Errata sheet LPC43S50, LPC43S30, LPC43S20

Rev. 1.6 — 20 April 2016

Errata sheet

3.9 ISP.2

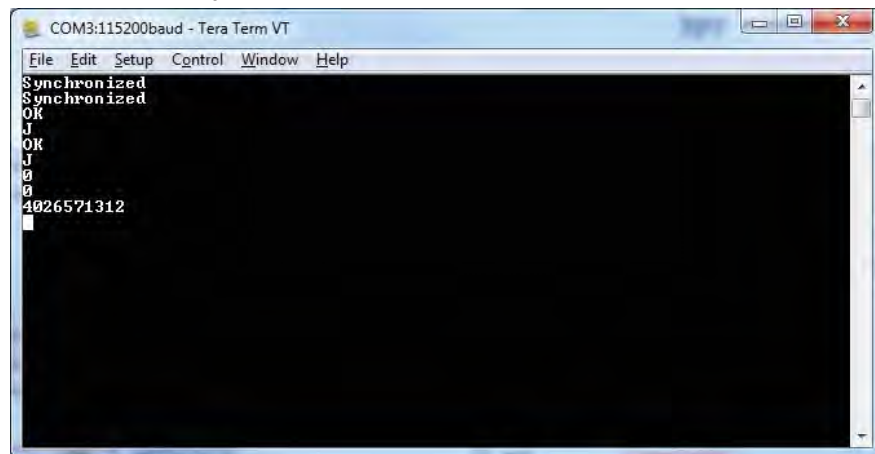
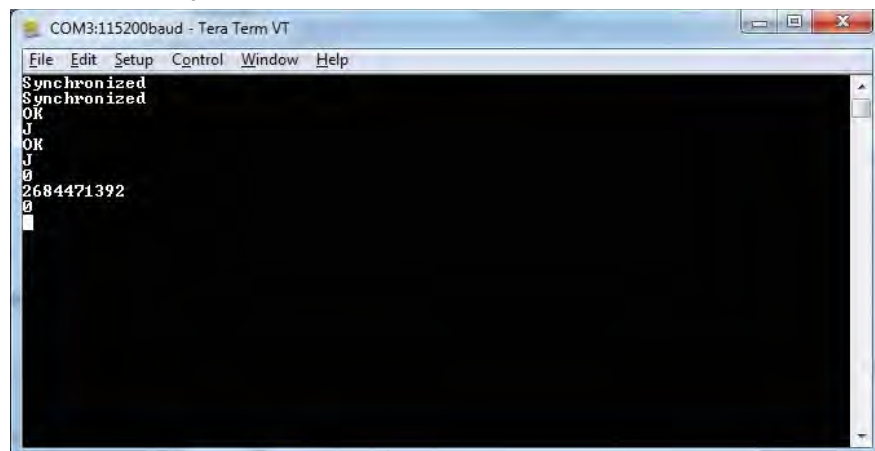
The 'J' command in ISP mode should return an error code, followed by an ASCII string representation of the part ID, followed by a 0. However what is actually returned is the error code, followed by a 0, followed by an ASCII string representation of the part ID. The problem is the last two items returned are swapped.

Incorrect example:

Correct example:

There is no work-around for this problem.

3.12 OTP.2

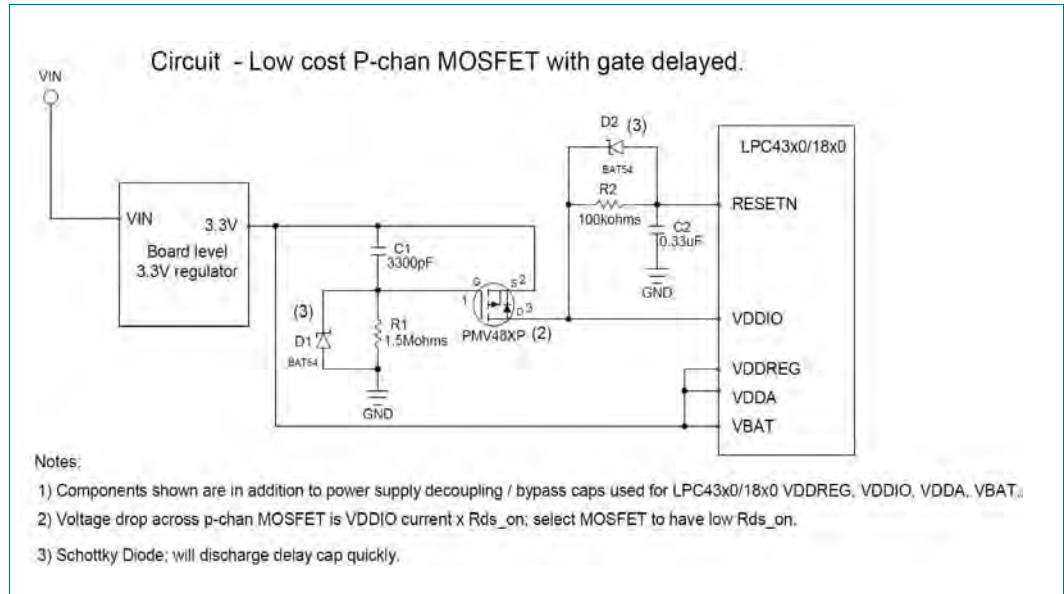
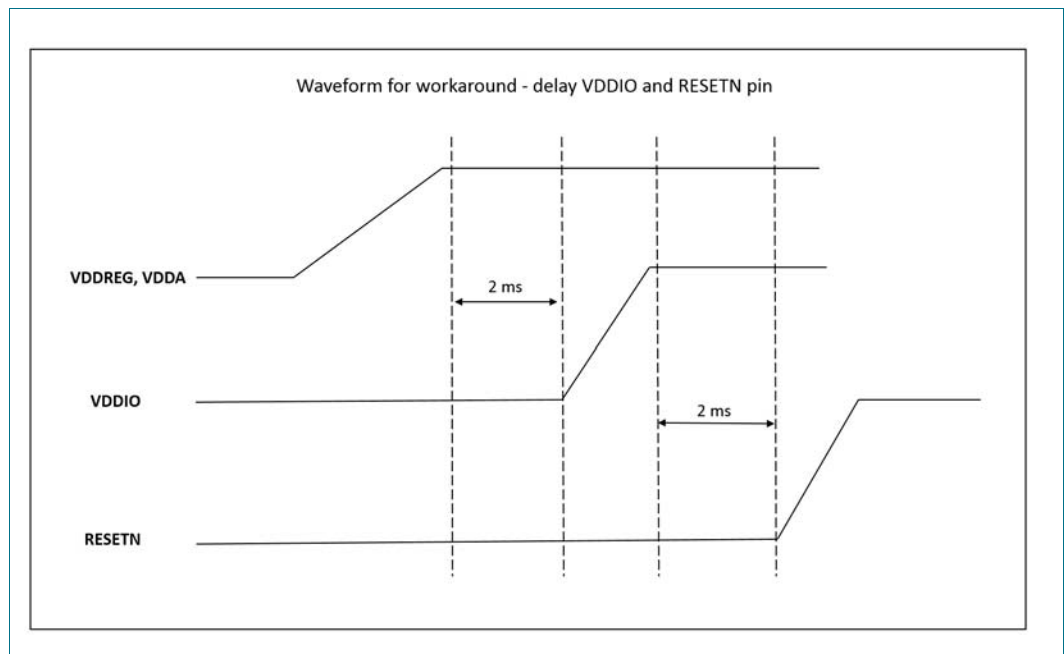
On all packages, repeated power cycling of the device may cause erroneous programming of the OTP banks. During ramp-up, the VDDREG supply voltage does not have enough time to settle and initialize the OTP controller before valid programming voltage is reached on the VPP pin. This may cause accidental programming of the OTP banks. Accidental programming of the OTP banks does not occur during Power-down of the supply voltage.

The following circuit diagram is an example that shows the P-channel MOSFET with the gate delayed and the R-C delay circuit connected to the RESETN pin.

The following diagram shows the waveform for the work-around.

- When OTP programming is not required, the VPP pin should be left as No-Connect (NC) because the VPP and VDDIO pins are separate.
- When OTP programming is required, do not tie VPP pin to VDDREG, VDDIO and VDDA pins. The voltage on the VPP pin should be delayed by 2 ms after the power supply on the VDDREG, VDDA, and VDDIO pins reaches the operating voltage level.

- Do not tie VDDIO to VDDREG and VDDA pins. The power supplied to the VDDIO pin should be delayed by 2 ms after the power supply on the VDDREG and VDDA pins stabilizes at the operating voltage level. The signal to the RESETN pin must also be delayed by 2 ms after the power supply on the VDDIO pin stabilizes at the operating voltage level.

Fig 3. PMC wake-up keep-out area

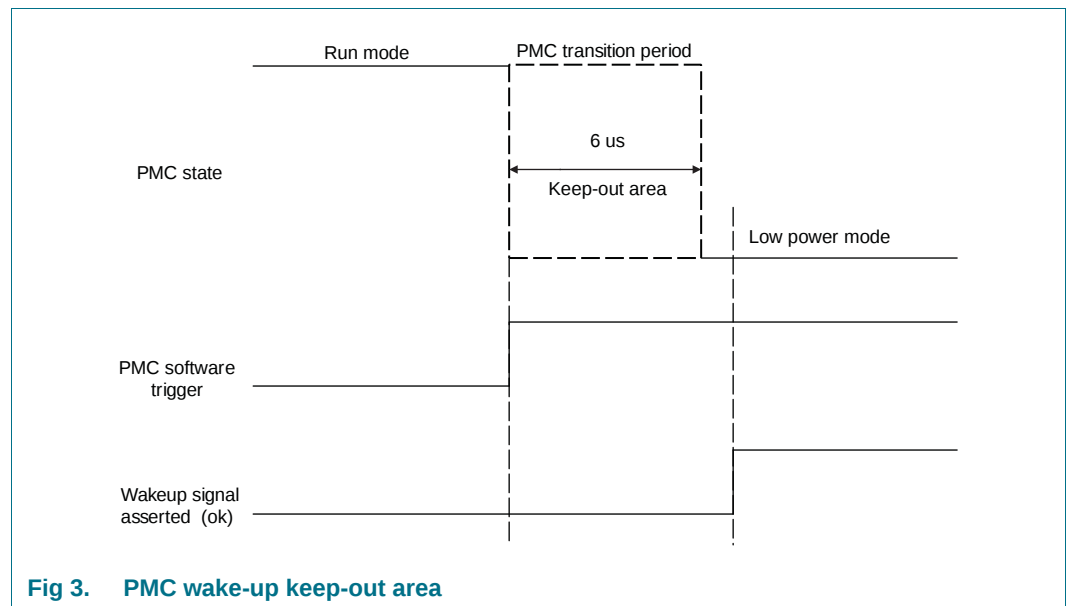
When the chip is in a transition from active to Deep Sleep, Power Down, or Deep Power Down, wake-up events are not captured and they will block further wake-up events from propagating. The time window for this transition is 6 μ S and is not affected by the chip clock speed. After a wake-up event is received during the PMC transition, the chip can only recover by using an external hardware reset or by cycling power.

Make sure that a wake-up signal is not received during the Deep Sleep, Power Down, or Deep Power Down transition period. An example circuit to work around this could include an external 6 μ S one shot which could be triggered via software using a GPIO line when entering Deep Sleep, Power Down, or Deep Power Down mode. The one-shot's output could be used to gate the wake-up signal(s) to prevent receiving a wake-up signal during the PMC transition period. Depending on the system design, it may also be needed to latch the wake-up signal(s) so that they will still be present after the one-shot's 6 μ S time-out.
